20 GENERIC ISSUES

In this chapter, the staff discusses its evaluation of (1) the compliance of the Westinghouse AP600 design with 10 CFR 52.47(a)(1)(iv) and 52.47(a)(1)(ii), and (2) the incorporation of operating experience into the AP600 design. The applicant for a standard design certification is required by 10 CFR 52.47(a)(1)(iv) to propose resolutions of unresolved safety issues (USIs) and medium- and high-priority generic safety issues (GSIs) defined in NUREG-0933, "A Prioritization of Generic Safety Issues," that are (1) technically relevant to the design and (2) identified in the applicable supplement to NUREG-0933. In addition, the applicant is required under 10 CFR 52.47(a)(1)(ii) to propose resolutions to the technically relevant portions of Three Mile Island (TMI) Action Plan items addressed in 10 CFR 50.34(f).

By letter dated June 26, 1992, Westinghouse made its application for standard design certification (SDC) of the AP600 standardized plant design in accordance with the provisions of 10 CFR 52.45. The design is described in the AP600 Standard Safety Analysis Report (SSAR) from Westinghouse. Therefore, the applicable date for the appropriate supplement of NUREG-093

Figure 21.6-14
CCTF Run 58, Core Differential Pressure Comparison

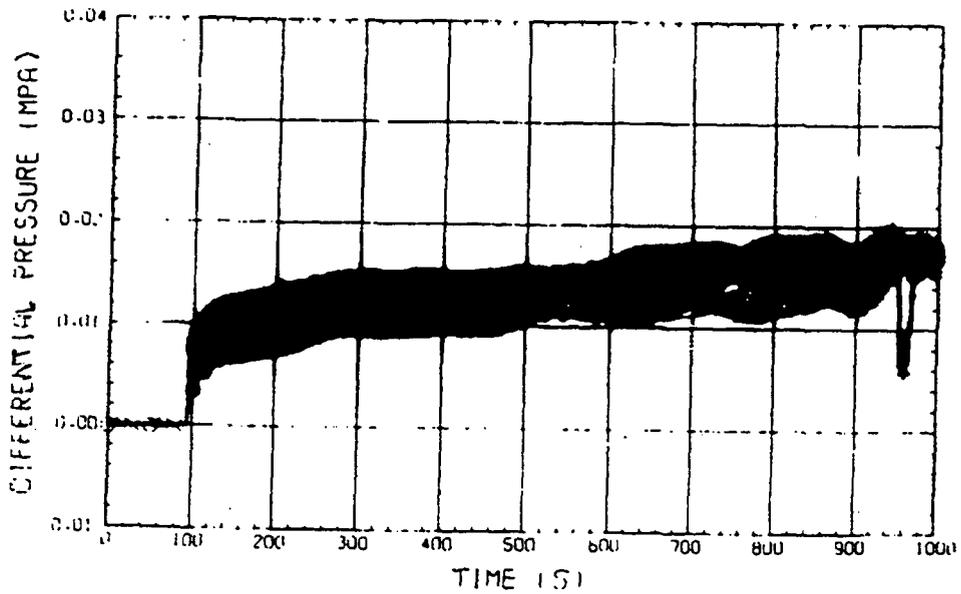
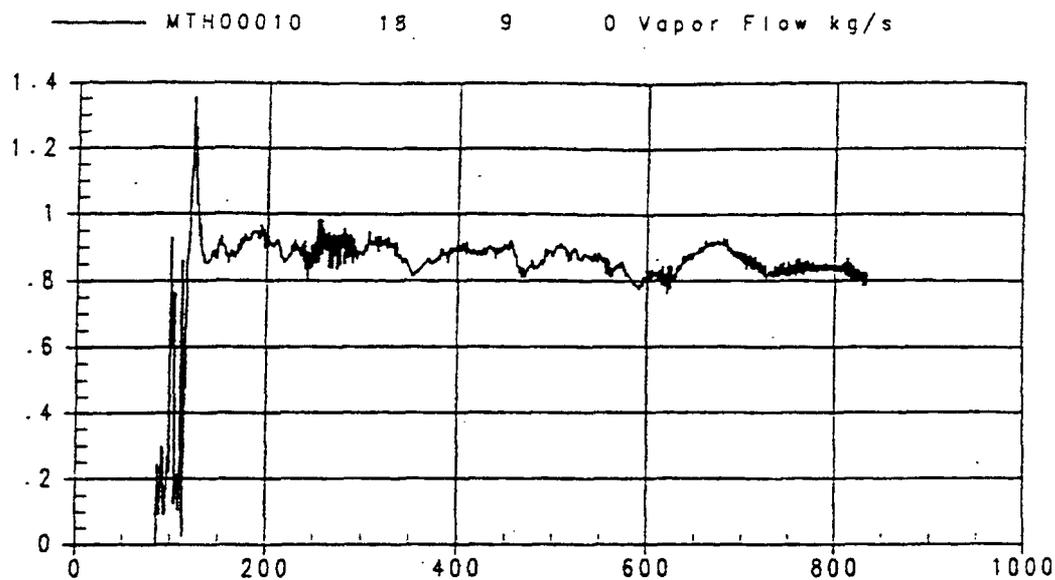
The upper plenum pressure is overpredicted for most of the test (Figure 21.6-12) because the more rapid quench advancement in the calculation results in higher steam production relative to the test. Downcomer and core differential pressure comparisons (Figures 21.6-13 and 21.6-14, respectively) show that the calculated downcomer pressure difference was within the band of the oscillations observed in the test, and the measured core pressure difference was well predicted. Regarding loop flows, the comparisons show that in general WCOBRA/TRAC results were relatively close to the test data except for the Cold Leg 1 and Hot Leg 4 steam mass flows, which were overpredicted (Figures 21.6-15 to 21.6-19).

In the response to comment 7(f) in its letter NSD-NRC-97-5171, dated June 10, 1997, Westinghouse noted the core and downcomer differential pressures were calculated well as shown in Figure 3.1-35 and Figure 3.1-36 of WCAP-14171-P. On review of those figures, it was found that the calculated downcomer differential pressure was within the band of the oscillations observed in the test and the measured core differential pressure was well predicted. Therefore, this item is closed.
